P-10381-2

ISSUE-2

S2713

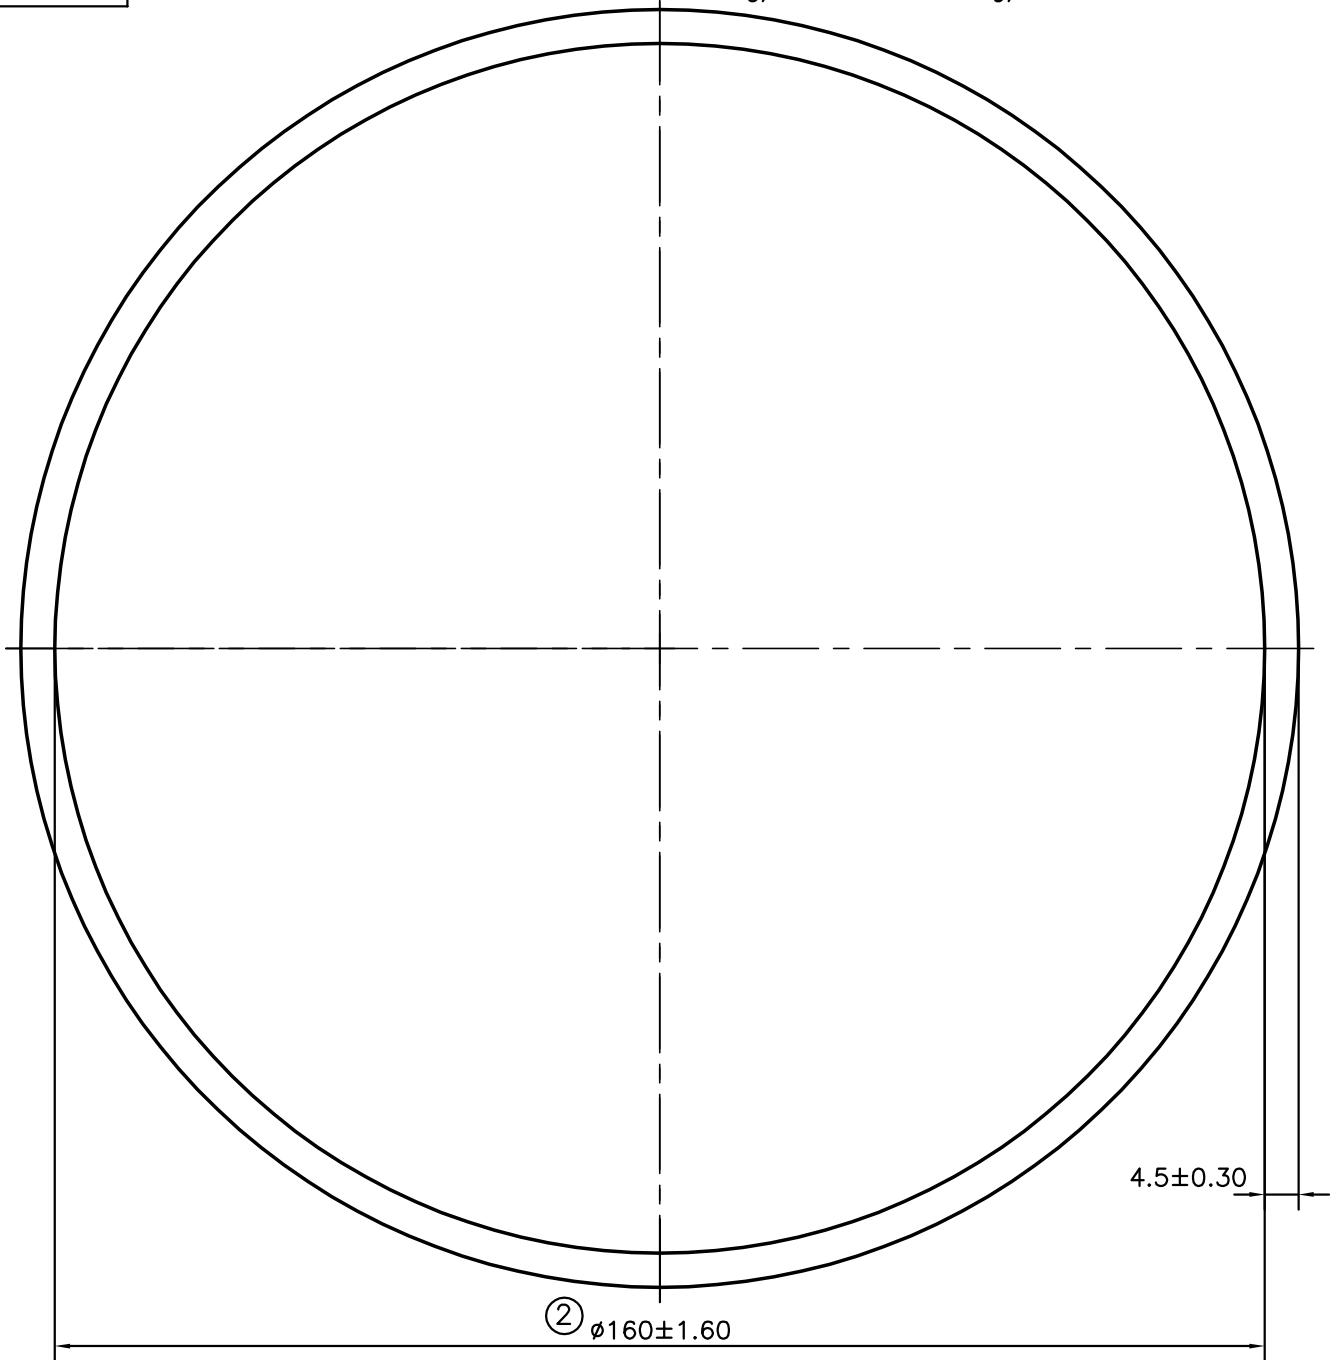
DIAMETER & TOLERANCE CHANGED FROM $\phi 160.1$ TO $\phi 160$ mm &

THICKNESS CHANGED FROM 4.0mm TO 4.5mm

WEIGHT ALSO CHANGED FROM 5.568 kg/M TO 6.279 kg/M
